**Moreland Planning Scheme
Referral 16: 215-219 Albion Street, Brunswick**

Priority Projects Standing Advisory Committee Report

17 November 2021

Figure 5 Comparison of Teilhaus apartments showing the omitted door on level 4 and door location on level 3

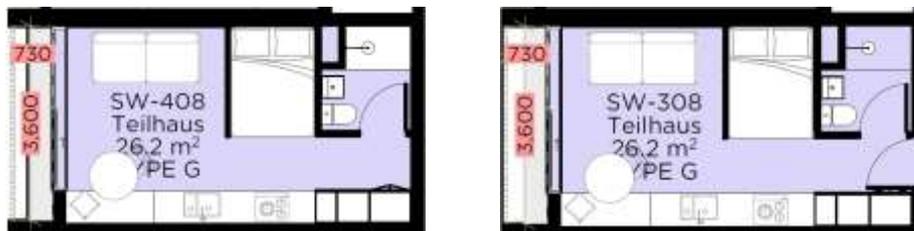
- the Teilhaus apartments on levels 4 and 5 do not meet the ventilation or accessibility standards in Clause 58 of the Planning Scheme because the plans omit entrance doors
- there is insufficient information to confirm compliance with Clause 58.

- that a reduced building height would be inconsistent with the emerging physical context along Albion Street and provide no material amenity benefit on adjoining or nearby properties
- the omitted doors on the two Teilhaus apartments was an oversight, and the plans would be revised to show an inward swinging door, consistent with the Teilhaus apartment in the northern section and on level 3 (see Figure 5).

The Teilhaus apartment layout is replicated or mirrored on levels 3, 4 and 5. The level 3 apartment shows the inward opening entrance door. Through simple logic, it is clear where the omitted door will be located to the southern Teilhaus apartment on levels 4 and 5. There is enough information to correct the plans and confirm compliance with Clause 58.
